Groundwater Application Review Summary Form

Application # LL- 1958

GW Reviewer Stacey Garrison/Travis Brown Date Review Completed: 8/30/2023

A. GENERAL INFORMATION: Applicant's Name: Bieze Property Investors LLC County: Polk

Water-Level Measurements in Nearby Wells

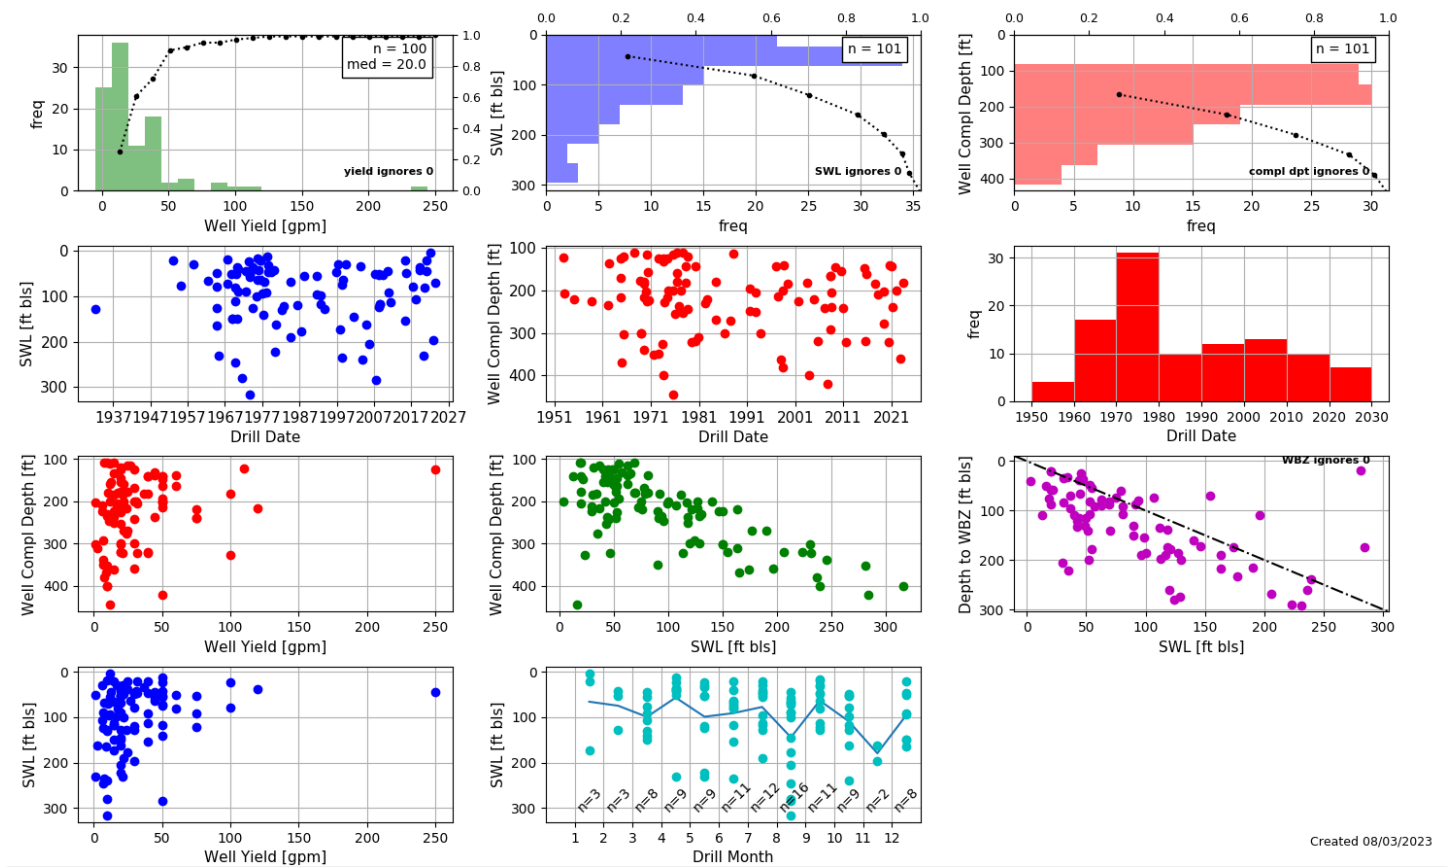
Water level trends for nearby (0 to 3 miles from POA) wells that utilize the CRBG with static water levels similar to the POA are overall declining (see Water Levels Measurements in Nearby Wells). Water levels have remained essentially unchanged in 1 well (YAMH 53325); increased in 5 wells (POLK 1225, POLK 52073, YAMH 3900, YAMH 3997); declined by less than 10 ft in 3 wells (YAMH 53317, YAMH 53318, 53324); declined by greater than 10 ft in 4 wells (YAMH 611, YAMH 51617, YAMH 51826, YAMH 52277). There are 5 well-sourced groundwater rights within 1 mile of the POA, and 19 spring-sourced water rights within 1 mile of the POA. Given the cuesta shape and incline of the CRBG formation and multiple faults in perpendicular orientation, it is difficult to determine which observation wells and groundwater rights have the highest likelihood of coincidence with the proposed POA. While there is not a preponderance of evidence that the groundwater resource is over-appropriated, **given the designation of the Eola Hills Groundwater Limited Area (OAR 690-502-0200), the extent of compartmentalization of CRBG fault blocks in this area, the overall declining water level conditions, and high density of groundwater and spring use in the area it is likely the proposed use is not likely within the capacity of the resource.**

Well Statistics 6S/3W-7 and surrounding sections

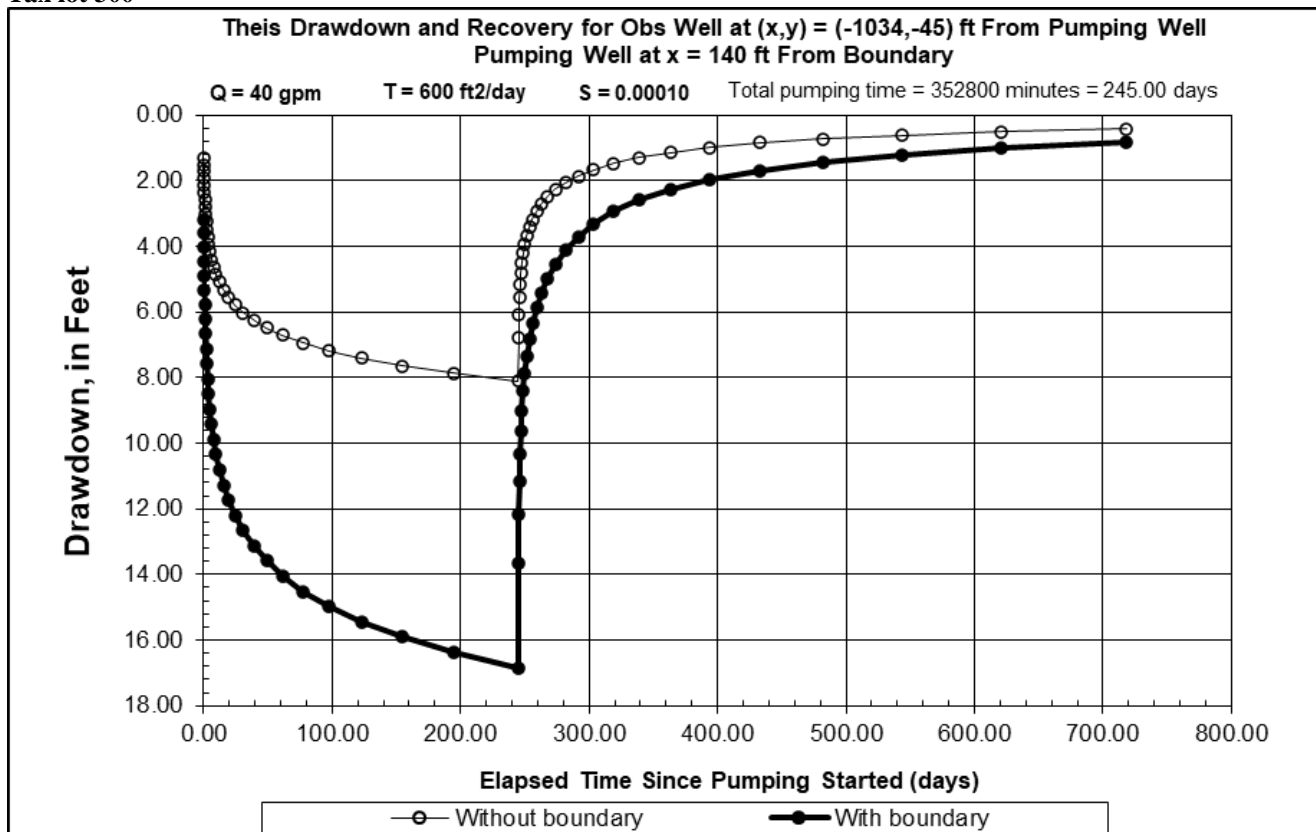
The proposed rate is 0.346 cfs (155.3 gpm). Most CRBG wells in the Eola-Amity Hills area produce less than 15 gpm, but some can yield more than 100 gpm (Price 1967). A query of wells in the area (see Well Statistics) shows a max of 250 gpm and median of 20 gpm; the proposed rate is 62% of the maximum and 777% of the median. Wells within 1 mile of the POA have a maximum reported yield of 110 gpm (with 135 ft of drawdown), and a median of 25 gpm. The well logs for the POA (POLK 993 and deepening POLK 1000) report 50 gpm and 100 gpm, but these were measured with an air test which can be less accurate than a pump test; in addition, drawdown for the 50 gpm air test was 128 ft after 1 hour, and for the 100 gpm air test was 23 ft after 1 hour. **It is not likely the POA is capable of supplying the total combined rate of 0.346 cfs (155.3 gpm), and therefore the proposed rate is not within the capacity of the resource.**

Theis Drawdown Analysis
Tax lot 300

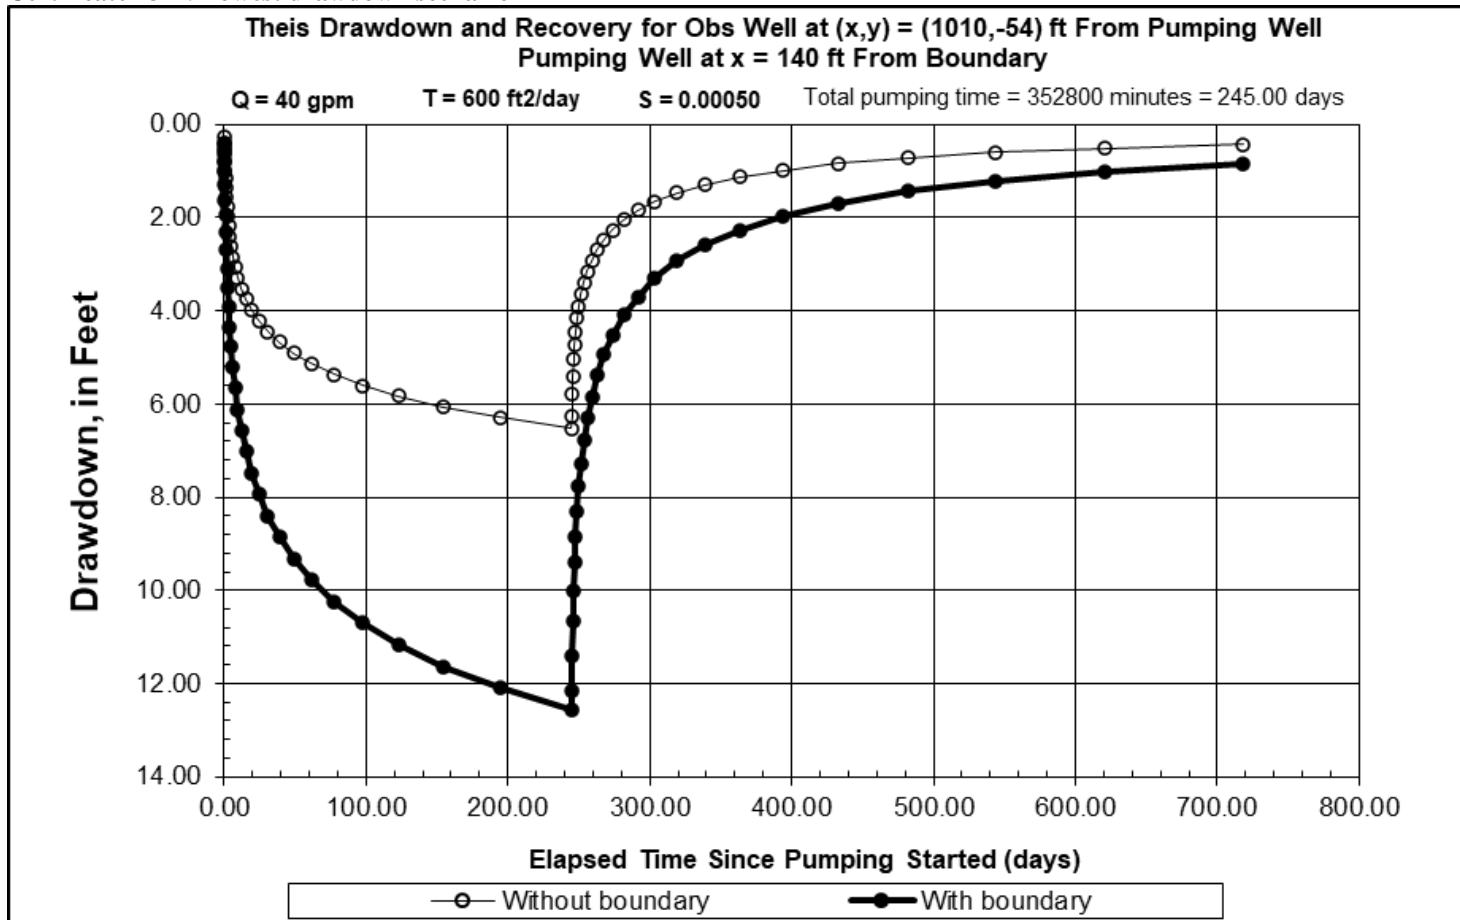
The nearest CRB groundwater user to the POA is the exempt domestic well serving tax lot 300 at 3730 Lone Star Rd NW Salem, OR, located ~1,016 ft west of the POA, at an elevation of ~378 ft msl. A well log could not be associated with this tax lot or address but is likely given the identification of well logs associated with other domestic tax lots in this area (POLK 1002, POLK 1020, POLK 990, POLK 51811, POLK 52789, POLK 1179, YAMH 1907, POLK 52960, YAMH 7739, YAMH 7738). It is likely the proposed use would cause some degree of well-to-well interference with the well serving tax lot 300. To assess the degree of drawdown, a Theis drawdown analysis was conducted for the proposed use (see attached Theis Drawdown Analysis). **Results indicate that the proposed use is likely to cause well-to-well interference with the well serving tax lot 300 that exceeds the threshold under the standard condition for basalt aquifers in the Willamette**

Basin. Based on this analysis of the available data and under the assumptions previously identified, groundwater for the proposed use is not likely within capacity of the resource.

Certificate 73429-lowest drawdown scenario

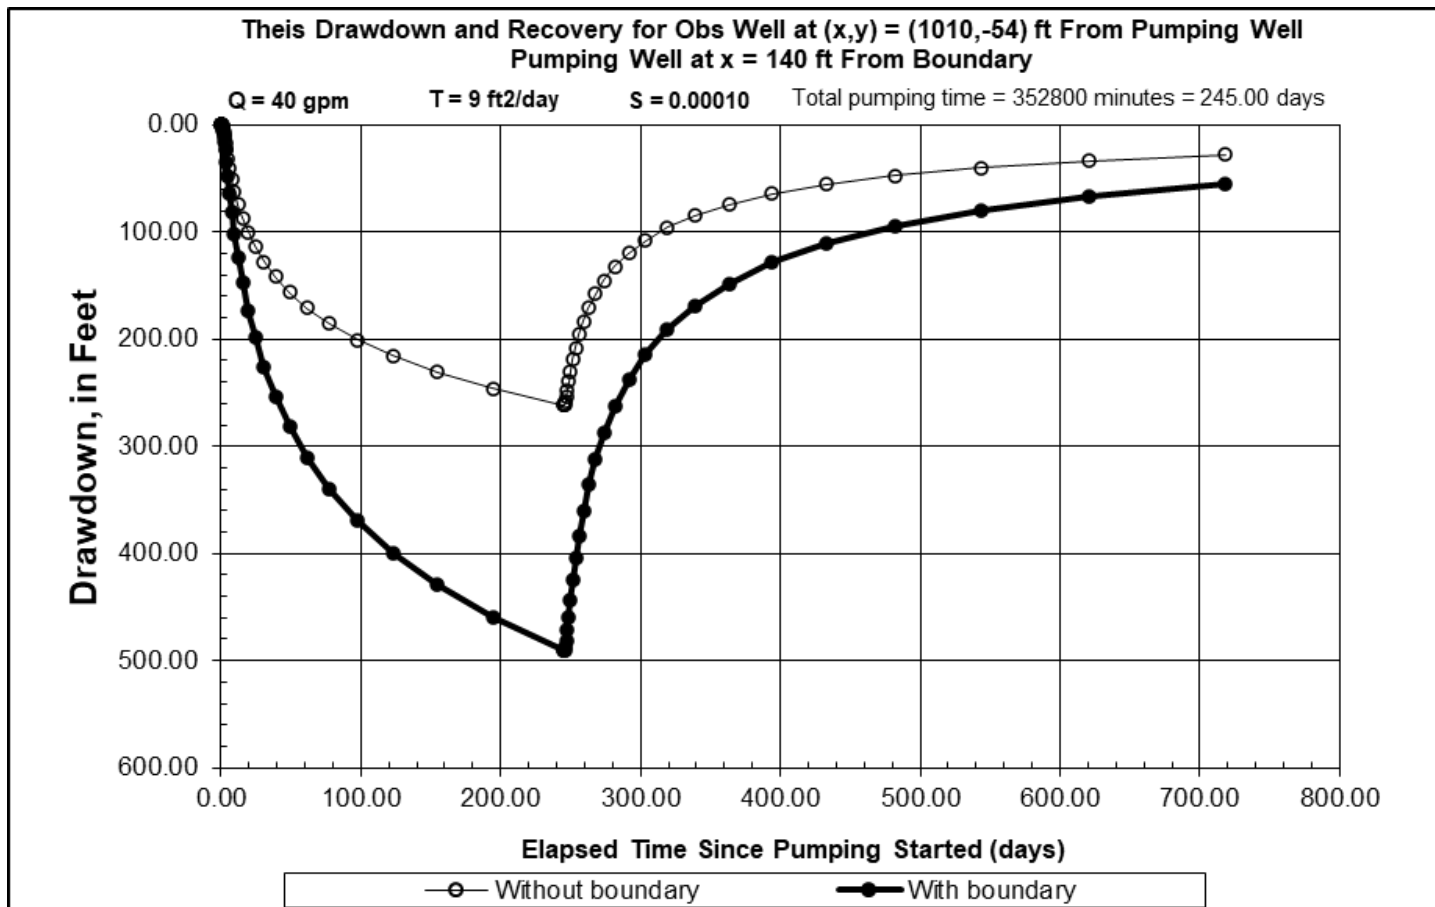
Analytic modeling using the Theis (1941) drawdown model with relevant parameters (Conlon et al 2005) suggests that pumping at the proposed rate for 245 days could plausibly cause between 12 and 490 feet of drawdown at the spring on Certificate 73429 (see attached Theis Drawdown Analysis-Certificate 73429 Lowest and Highest Scenario). The large range of plausible outcomes makes it difficult to determine whether the proposed use is likely to interfere with the spring and cause a senior user not to receive their entitled water. However, given the strong potential for injury to the certificated springs under the proposed rate, and the unknown sensitivity of the springs to drawdown, the Limited License should be conditioned per Special Condition 7, above.

7. Water use under this limited license shall be shut off if Certificate 73429 does not receive the water to which it is legally entitled. Water use shall remain shut off until the following spring, unless it is specifically re-authorized by The Director.
